Amendments to the Drawings:

Attachment: Annotated Sheets Showing Changes

REMARKS/ARGUMENTS

Fig. 18C

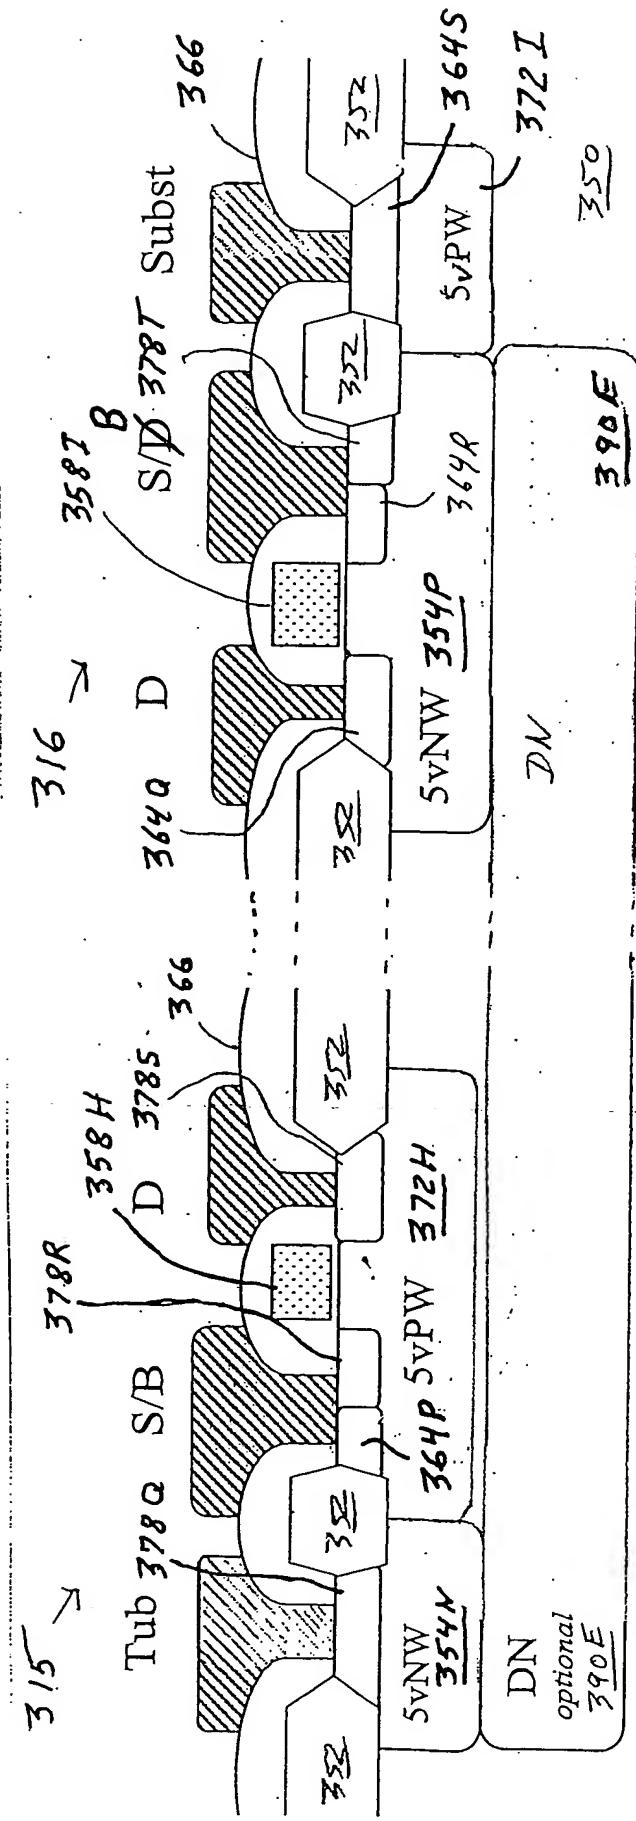
In Fig. 18C, the reference numeral 364P, which is referred to at page 66, line 4, of the substitute specification, has been added, and the designation of the source-body contact has been corrected from "S/D" to "S/B".

Interlayer Dielectric
Fig 33D

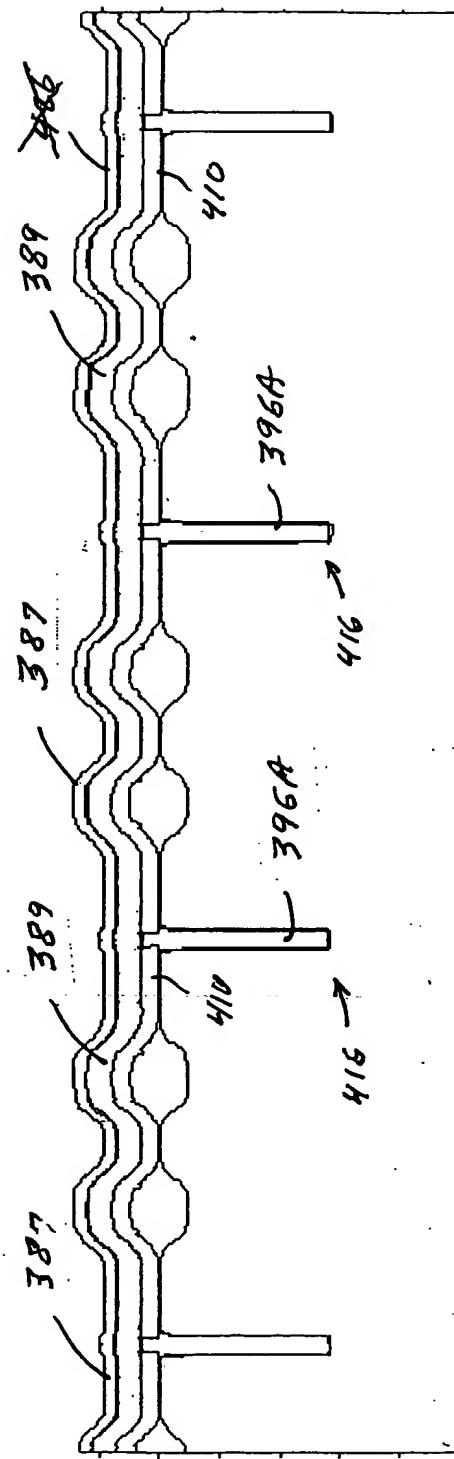
In Fig. 33D, the reference numeral 486 has been deleted. It is not referenced in the specification.

Interlayer Dielectric Deposition and Etch
Fig. 64B

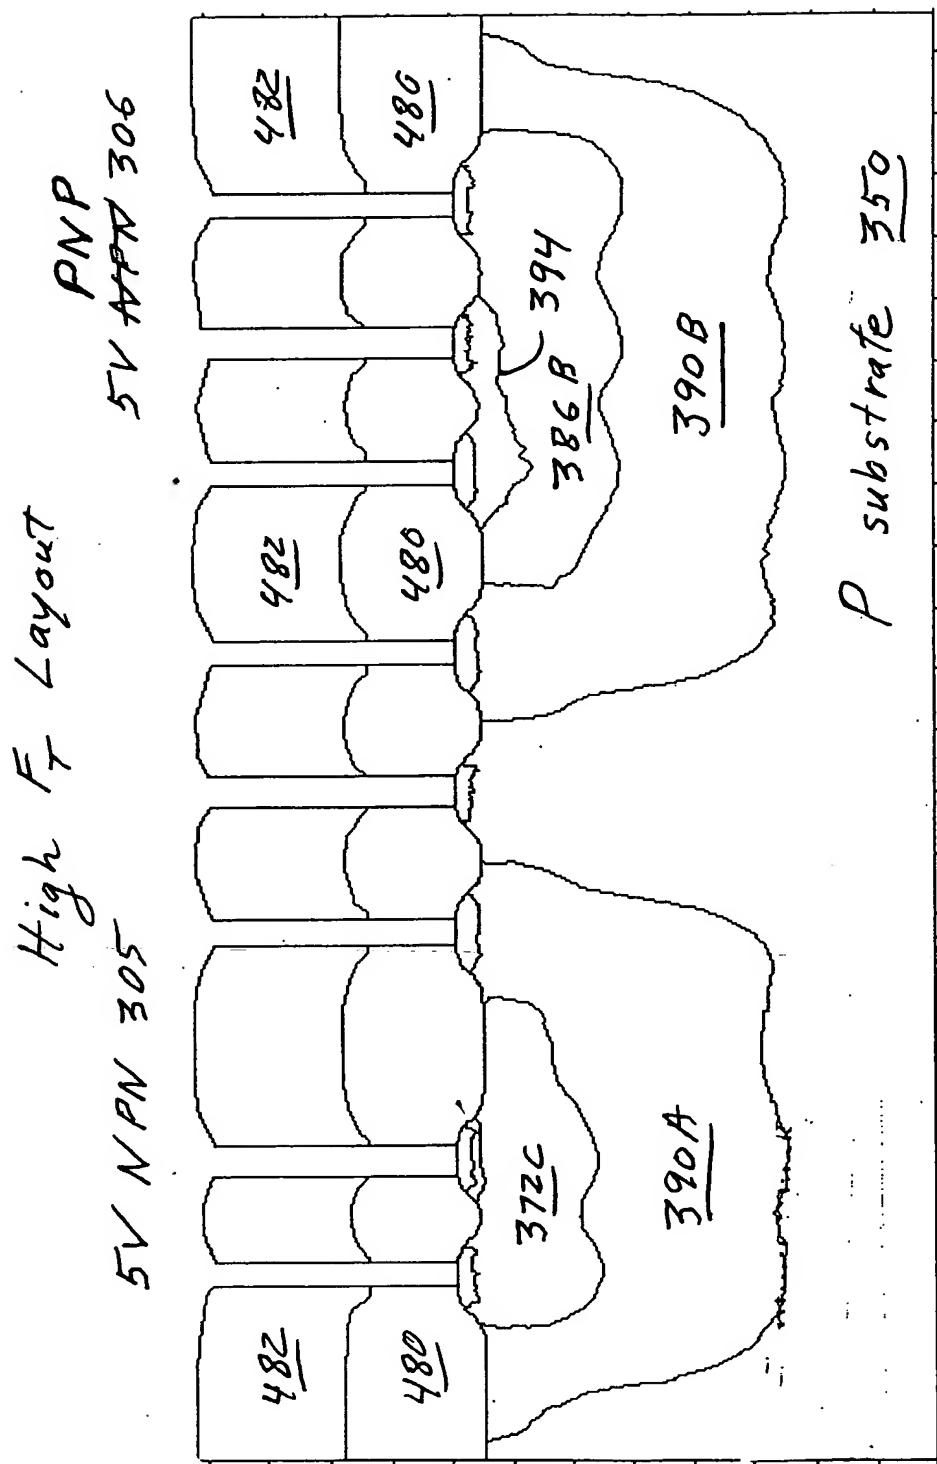
In Fig. 64B, the description of the 5 volt transistor 306 as been corrected to "PNP."

Fig. 18H

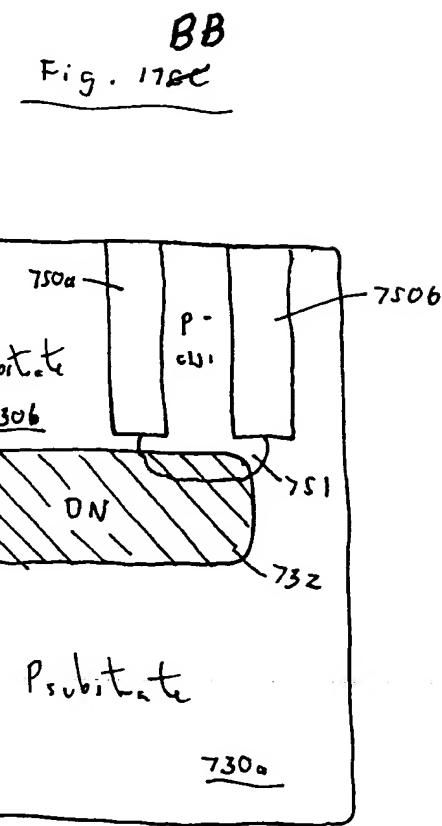
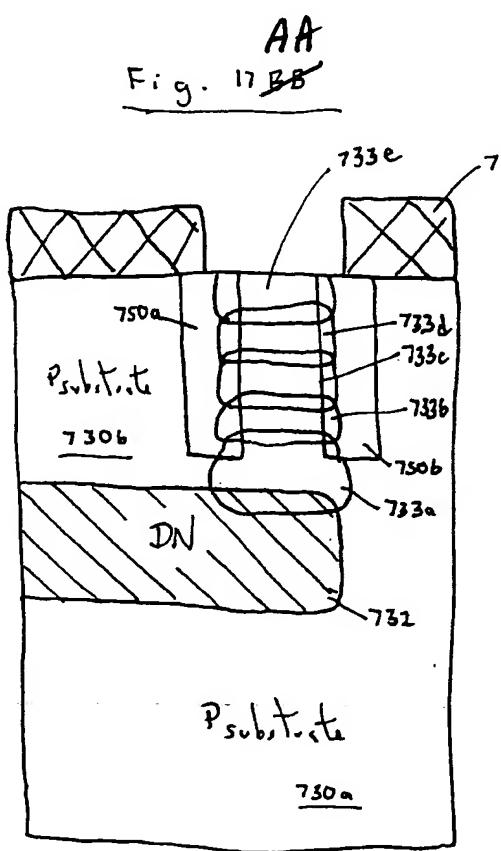
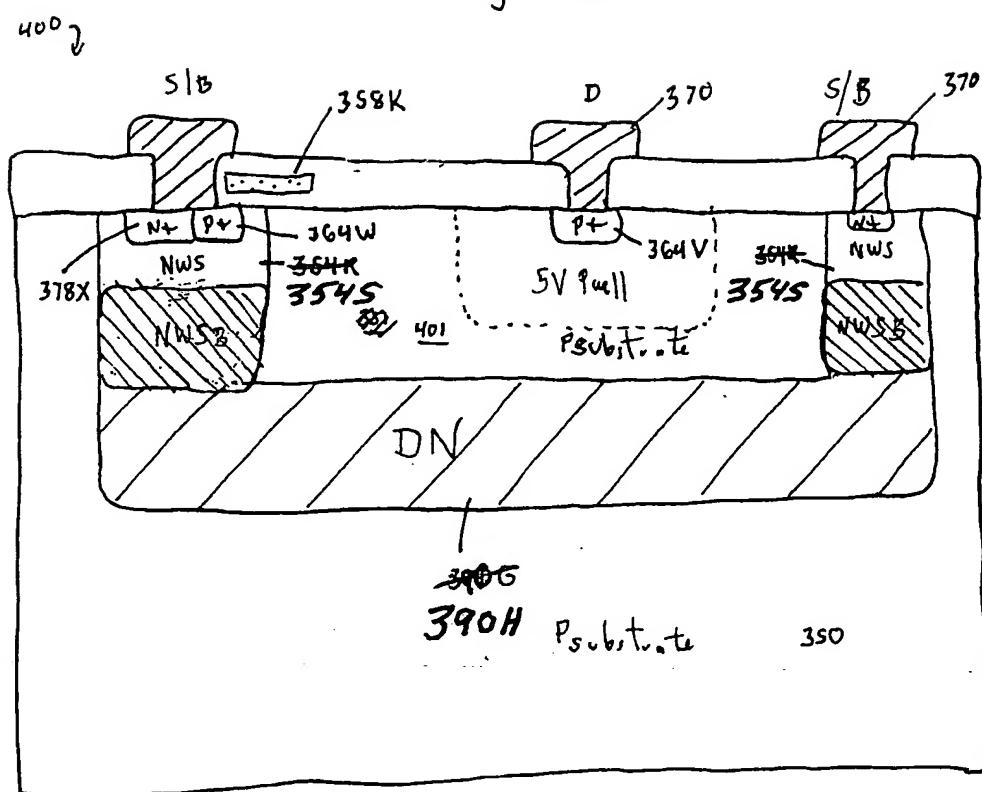
In Fig. 18H, the reference numeral applicable to the well NW5 has been changed from 354R to 354S to eliminate the conflict with the similarly numbered element in Fig.

18G; and the reference numeral applicable to the deep N layer has been changed from 390G to 390H to eliminate the conflict with the similarly numbered element in Fig. 35A.
